City of Detroit
Inter-Departmental Communication

RE: Petition No. 639
Request to Encroach Into Baltimore St. at 207 East Baltimore St. with a Canopy,
Wall Sconces and Lighting

**REQUEST ENCROACHMENT
 INTO E. BALTIMORE
 AT 207 E. BALTIMORE**
 (With Canopy, Wall Sconces & Uplighting)

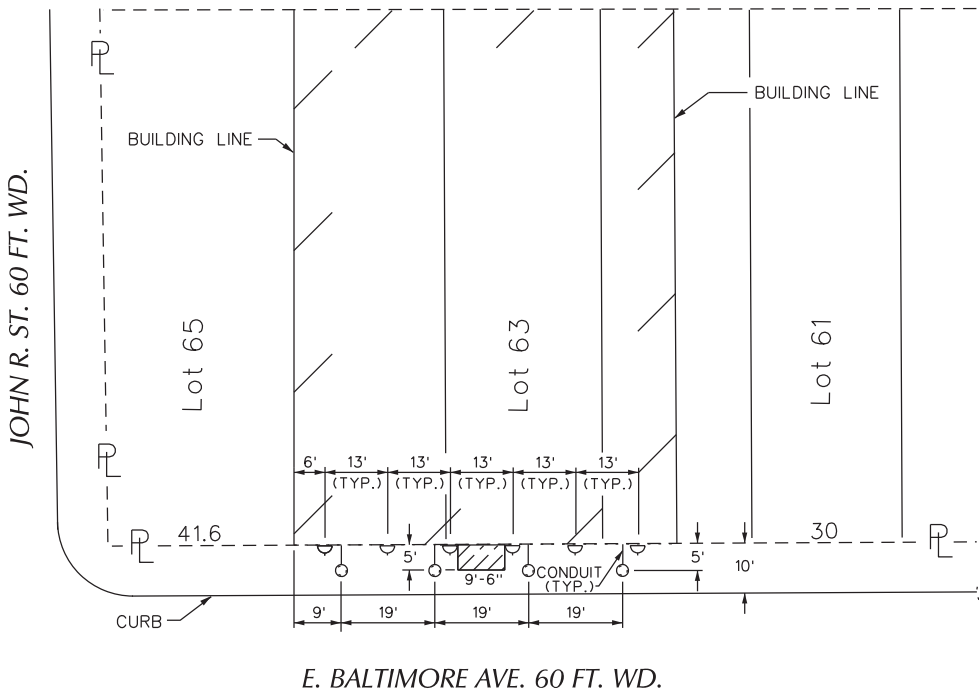
- Our records indicate that there is a water main in Baltimore St. DWSD has no objections to the encroachment, if the petitioner agrees to follow the terms stated in the attached Provisions for Encroachment.
